Device	SAF-C161JI-32RF, SAK-C161JI-32RF, SAF-C161JC-32RF, SAK-C161JC-32RF, SAF-C161CS-32RF, SAK-C161CS-32RF
Marking/Step	Step (E)ES-CA, CA
Package	P-TQFP-128-2

This Errata Sheet describes the deviations from the current user documentation.

Current Documentation

Figure 1 Additional Jitter

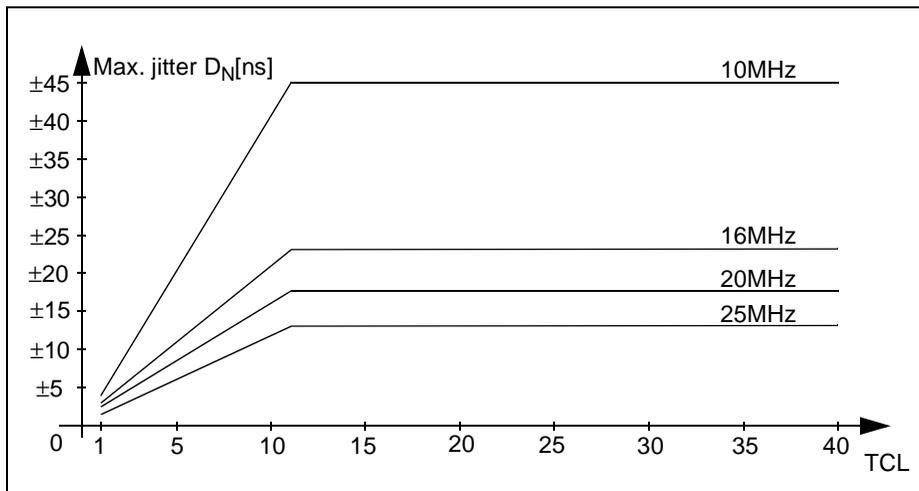
In systems where the PLL is used for generation of the CPU clock frequency, the PLL jitter can increase under certain circumstances and exceed the specified value.

The value of the additional jitter is not a fixed one but it depends on the kind of activity on the external bus or output pins. The additional jitter increases with the number of output/bus pins which are switched at the same time to a new voltage level because the problem is caused by noise on the on-chip power supply.

The additional jitter has the maximum effect if only one TCL is considered (period jitter). This can have an influence to the bus timings with one TCL.

The additional jitter decreases with the number of consecutive TCLs (accumulated jitter). The accumulated jitter has an effect on timings with more than one TCL (certain bus timings, CAN bus timing, serial interfaces).

For an accumulated period of $N \cdot \text{TCL}$ the new maximum jitter $D_N[\text{ns}]$, which exceeds the specified value in the Data Sheet, is computed using the formula:

$$D_N[\text{ns}] = \pm[(50 / f_{\text{CPU}} + 164 / f_{\text{CPU}}^2 - 0.04) * (N / 2 - 1) + 1180 / f_{\text{CPU}}^2 + 0.2]$$

This approximated formula is valid for $1 \leq N \leq 12$ and $10 \text{ MHz} \leq f_{\text{CPU}} \leq 25 \text{ MHz}$.

For all accumulated periods longer than 12 TCL the $N=12$ value can be used; see figure below.

In case that the additional jitter causes problems in the system which cannot be relaxed with software adapted timing parameters, then direct drive or prescaler mode can be used. If the maximum frequency of the on-chip oscillator (16 MHz) is not sufficient then an external clock generator can be used.

Figure 2 C161JI/JC/CS-32RF Clock Configuration

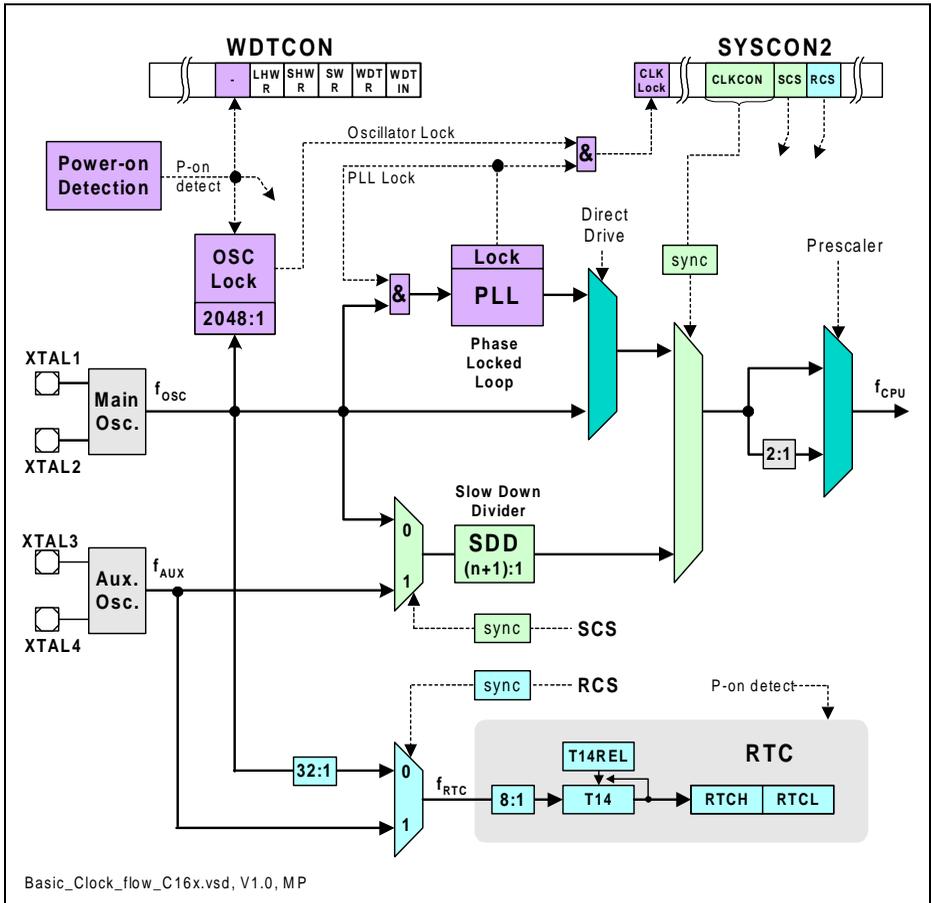
For the modification of the internal clock multiplexer controlled via SCS or RCS in register SYSCON2 a clock pulse from XTAL3 is required. The register contents SCS and RCS can be modified without a clock pulse from XTAL3 but this has no effect on the system because SCS and RCS are synchronized with XTAL3.

- When the system is running in direct drive or PLL clock mode, it is not allowed to switch the clock path to SDD mode via software because if $SCS = 1$ (modification via software has no effect on the clock multiplexer) then the system gets no clock.
- When $SYSCON2.RCS = 1$ the RTC will stop (modification via software has no effect on the clock multiplexer).

Consider the conditions to get a defined clock configuration at power-on.

Figure 3 SSCTB Timing

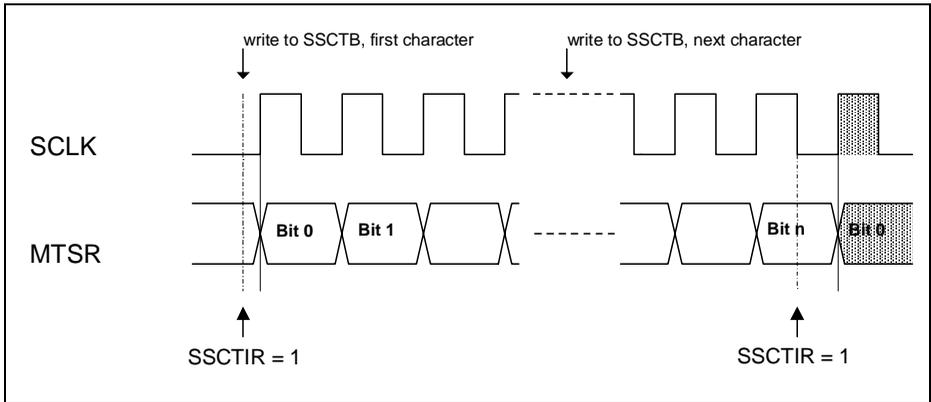
When SSCTB has been written while the transmit shift register was empty (and the SSC is enabled), flag SSCTIR is set to '1' directly after completion of the write operation, independent of the selected baud rate. When the transmit shift register is not empty when SSCTB was written, SSCTIR is set to '1' after the last latching edge of SCLK (= 1/2 bit time before the first shifting edge of the next character). See also e.g. C167CR User's Manual V3.1, p. 12-5.

The following diagram shows these relations in an example for a data transfer in master mode with SSCPO = 0 and SSCPH = 0. It is assumed that the transmit shift register is empty at the time the first character is written to SSCTB:

Typically, in interrupt driven systems, no problems are expected from the modified timing of flag SSCTIR. However, when flag SSCTIR is polled by software in combination with other flags which are set/cleared at the end or at the beginning of a transfer (e.g. SSCBSY), the modified timing may have an effect.

PORT.D3 P3.15 and Frequency Output Signal Path

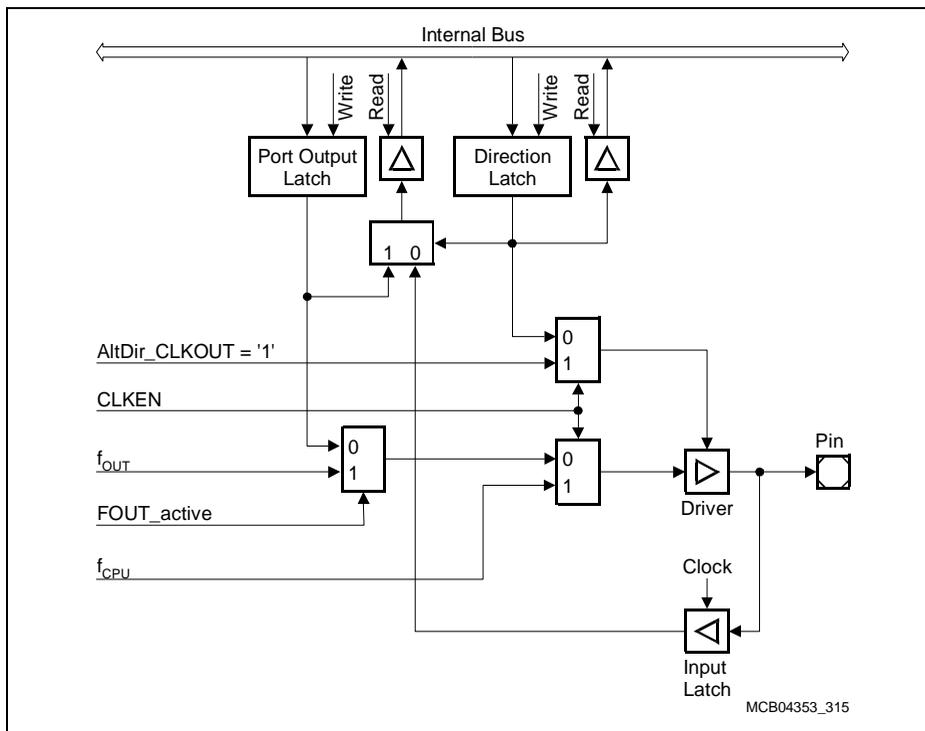
To enable the frequency output signal f_{OUT} bit CLKEN in register SYSCON must be cleared (before EINIT) and f_{OUT} must be enabled in register FOCON. In contrast to signal CLKOUT the direction latch has to be set by software to enable f_{OUT} .
